ADDENDUM # 1

5P201-17-5050

Installation and Mechanical and Electrical Components Replacement at the Carillon Navigation

ADDENDUM N° 1

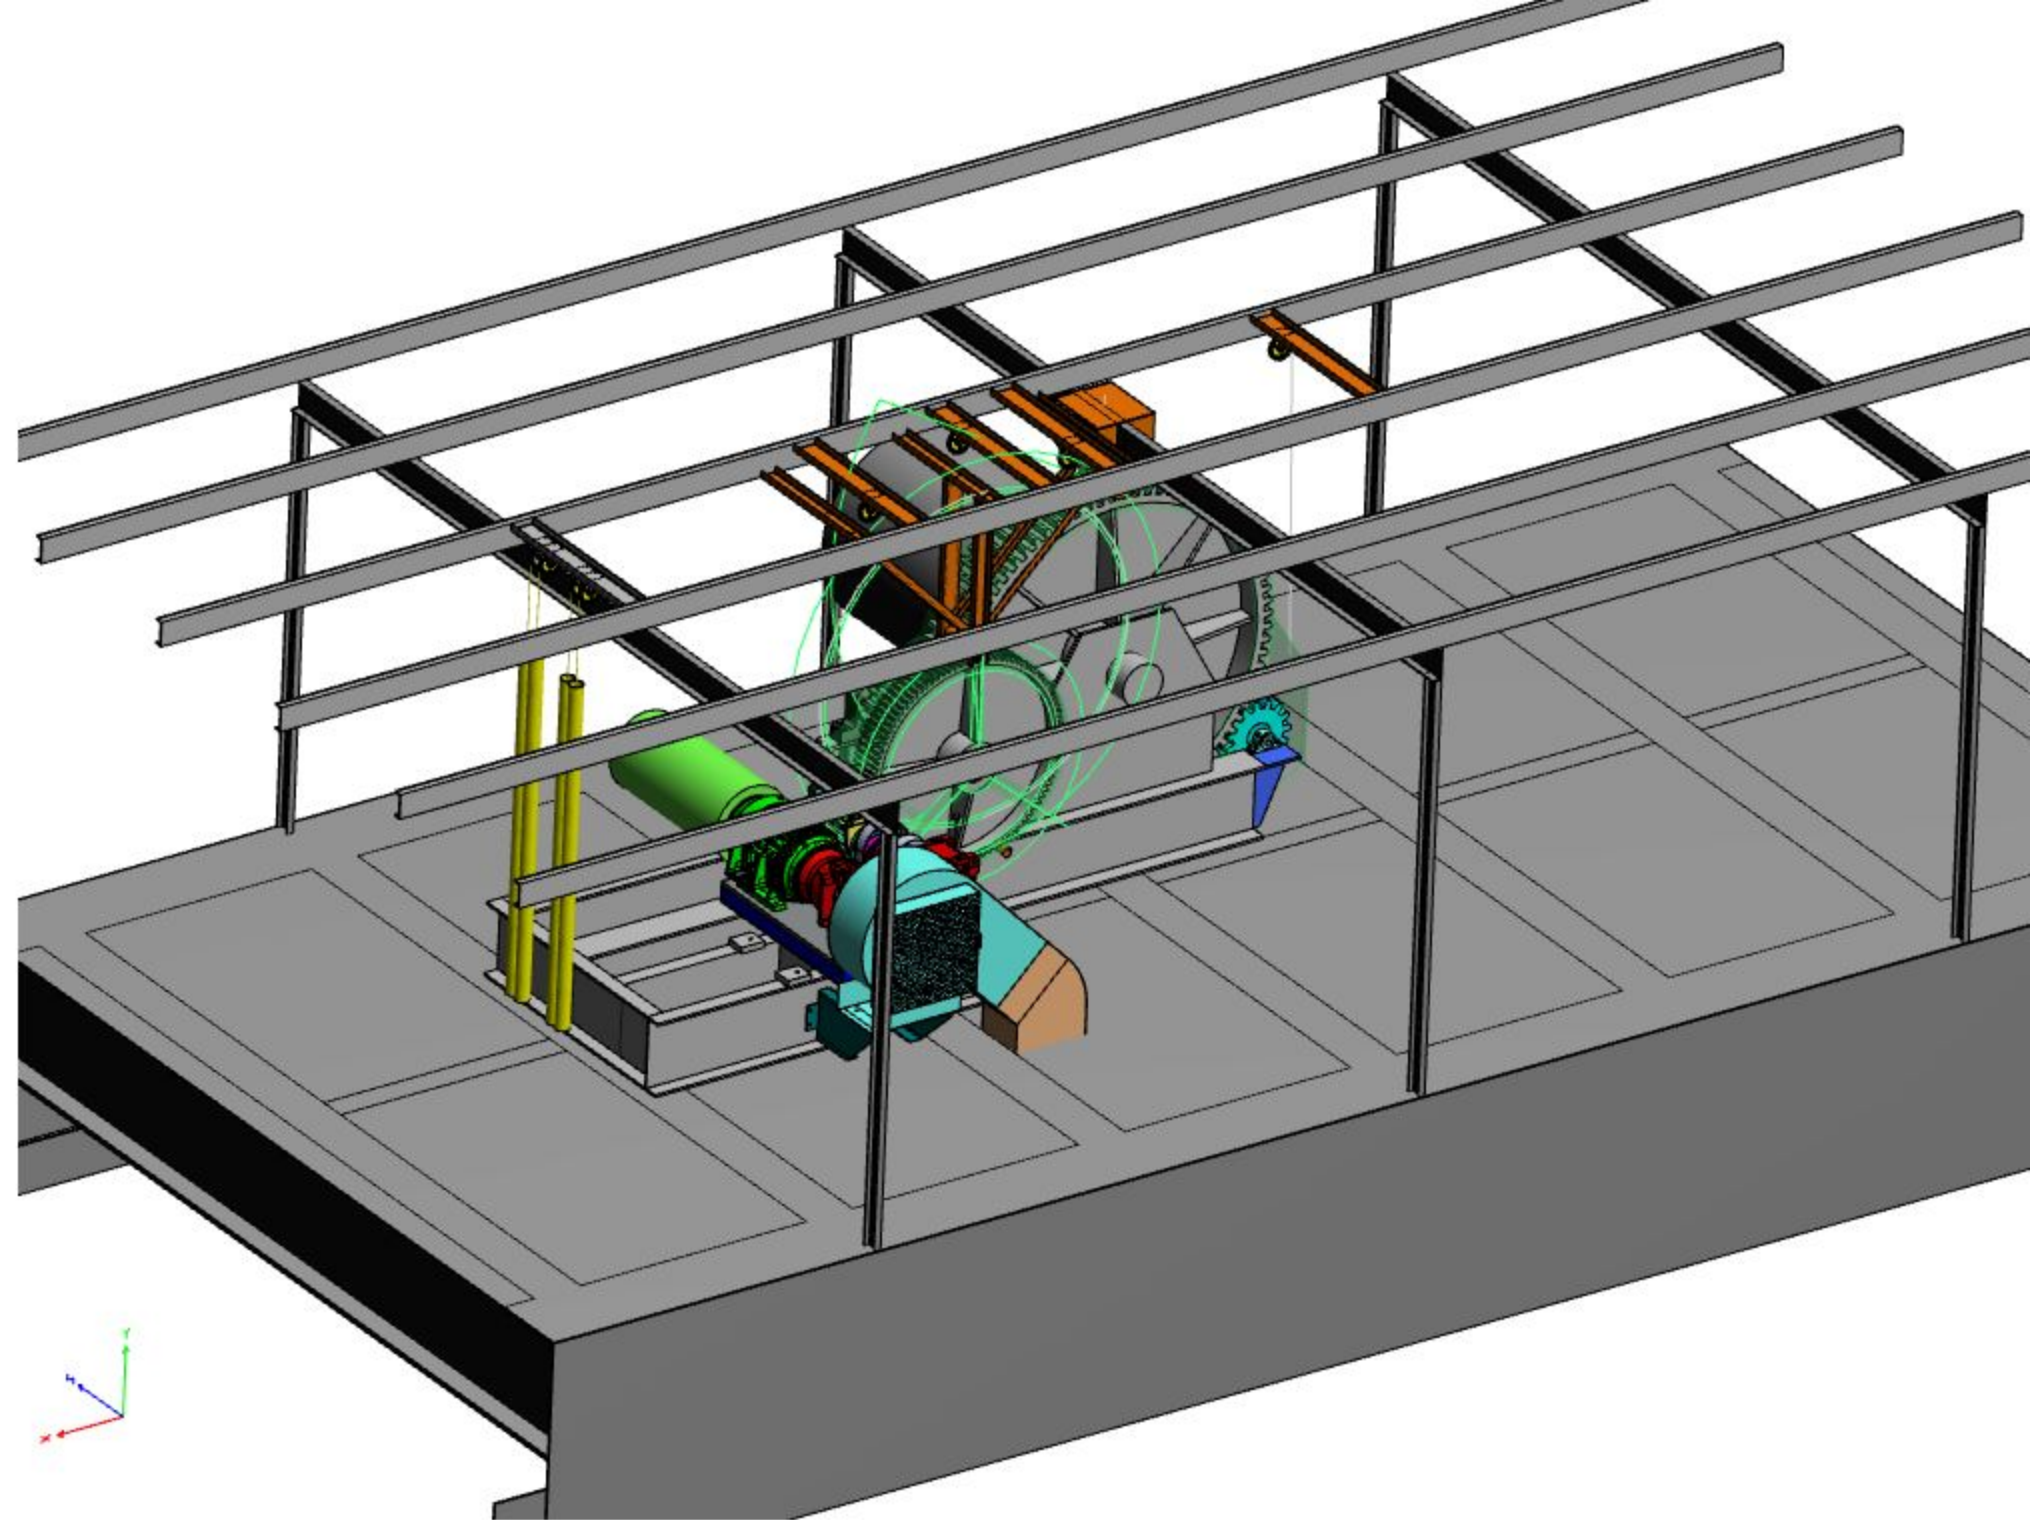
5. What are the equipment weights (gearbox, fan brake motor)?

Current reducer: unknown weight. See reference drawing attached.

**Take in account that the weight full of oil is higher than the monorail capacity (1T). The contractor shall propose its method to remove the current reducer for disposal.

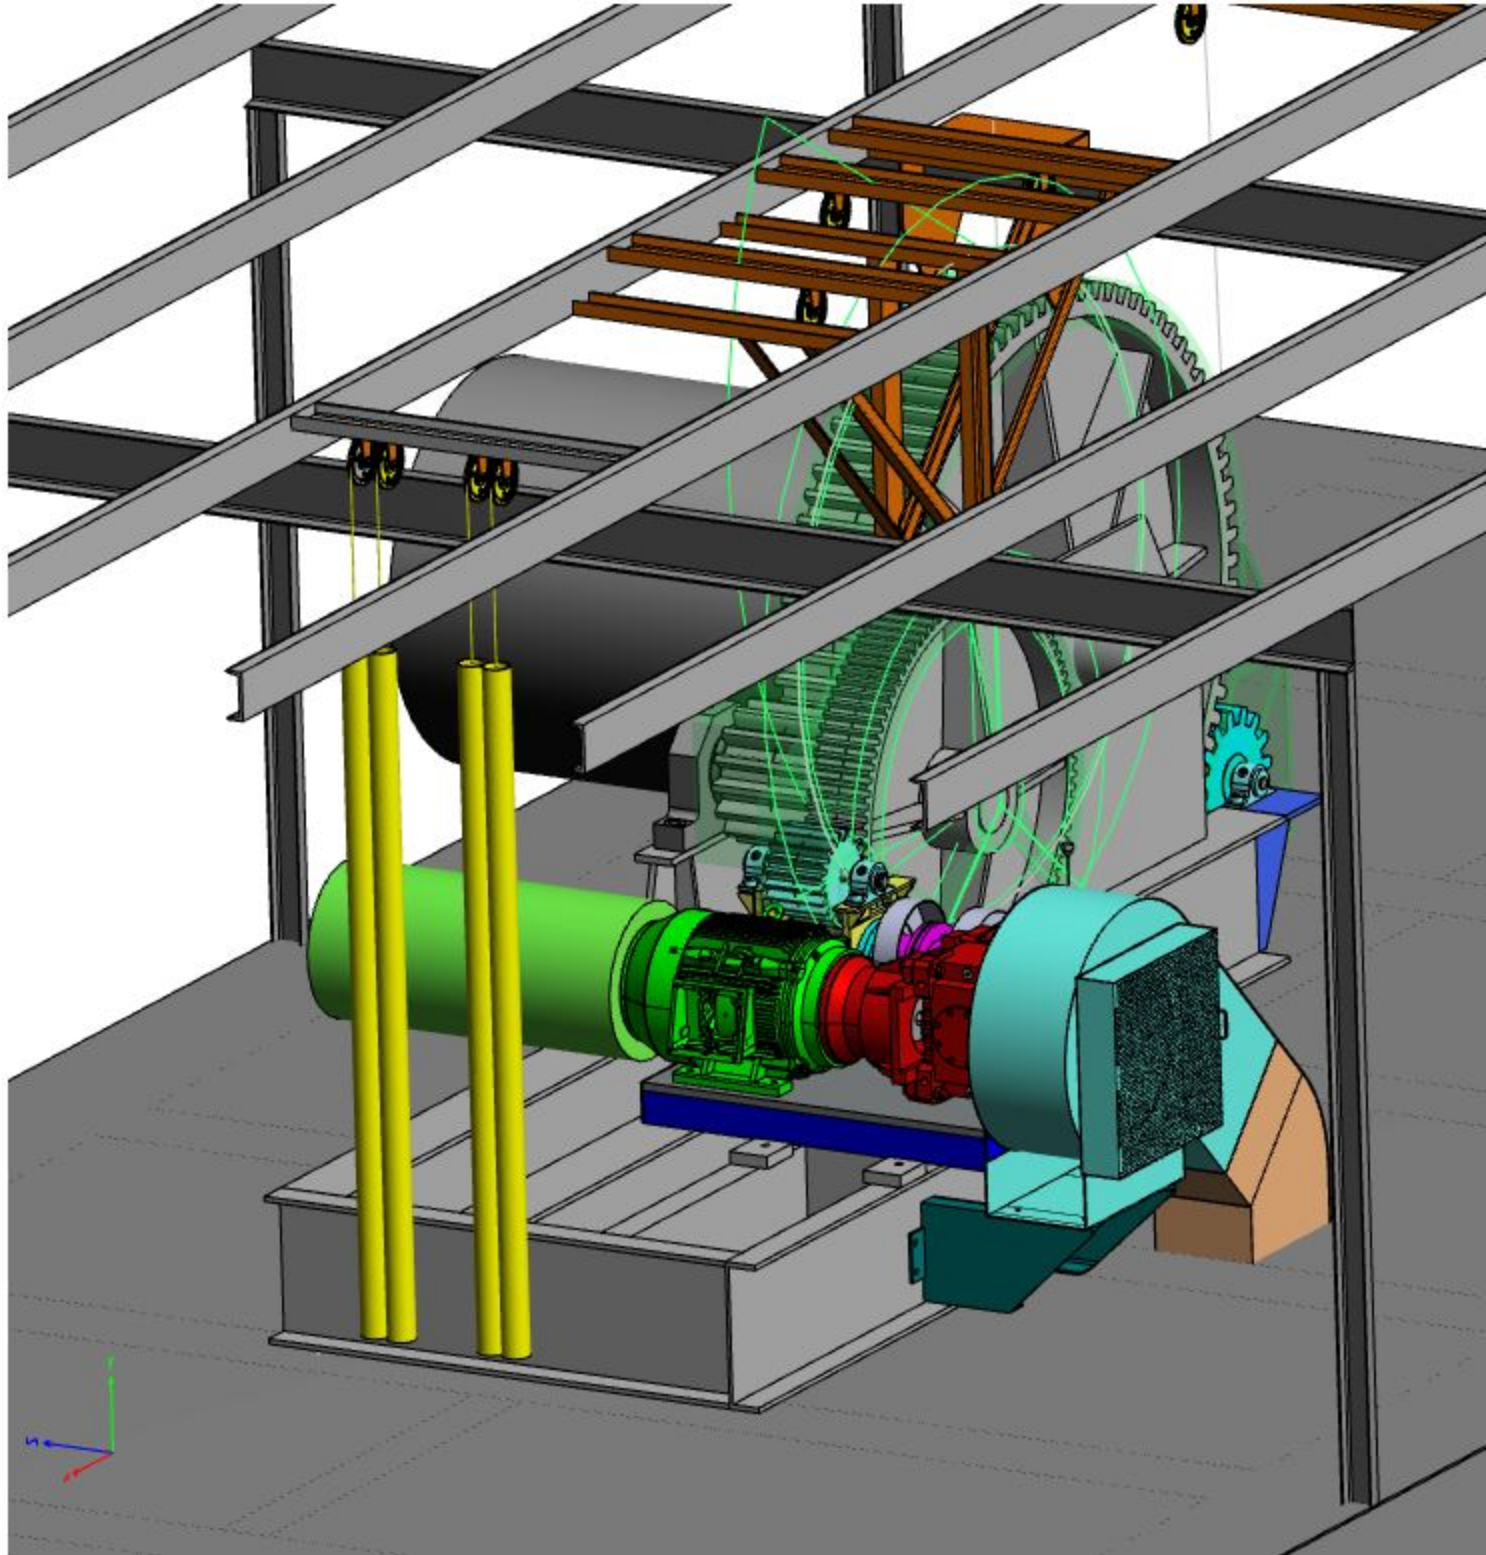
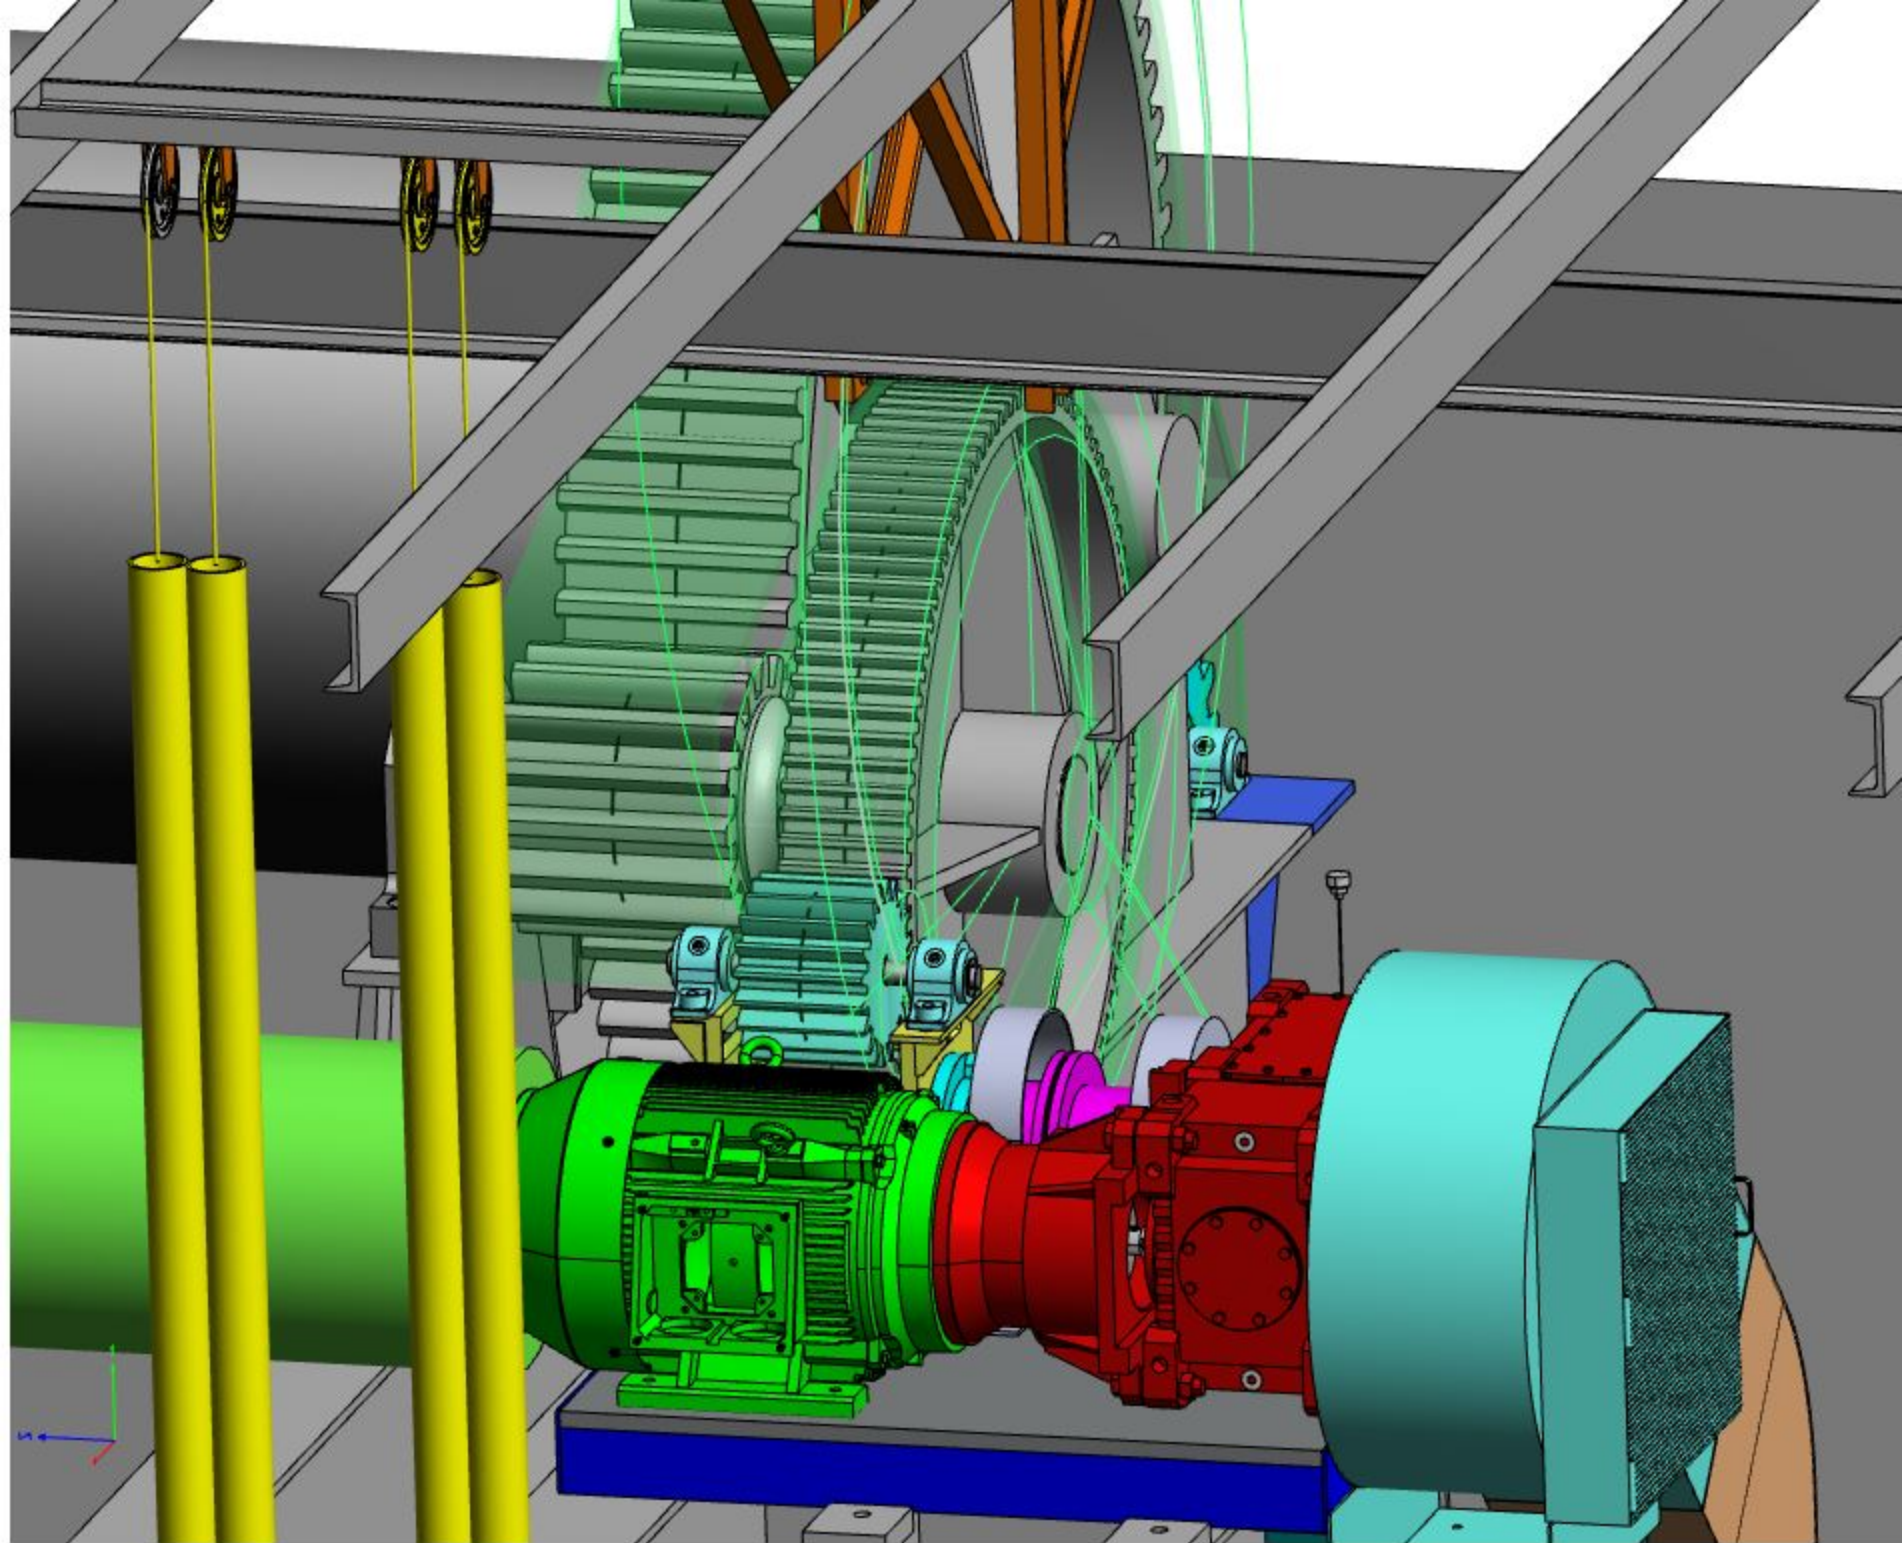
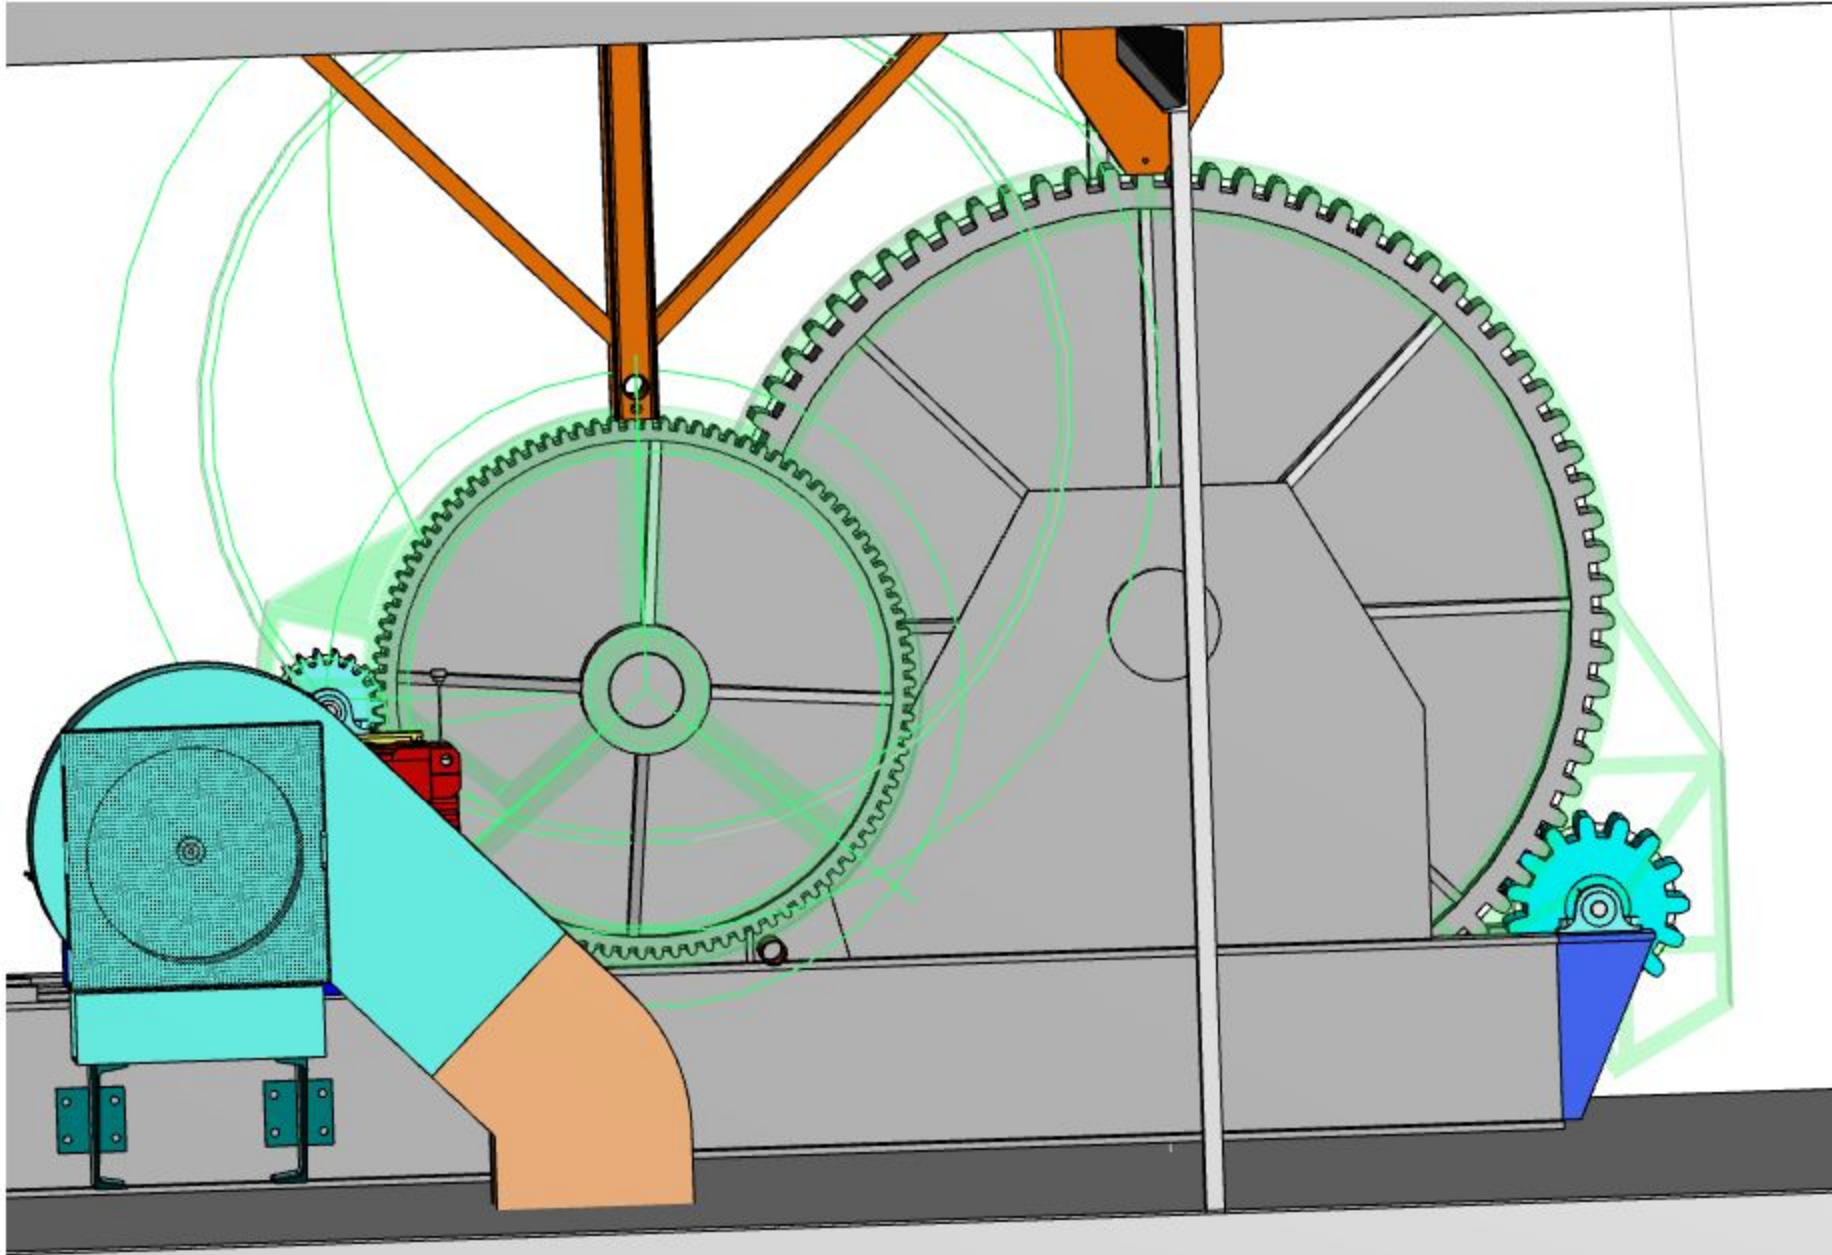
13. To facilitate understanding, see attached 3D for the works at the vertically door.
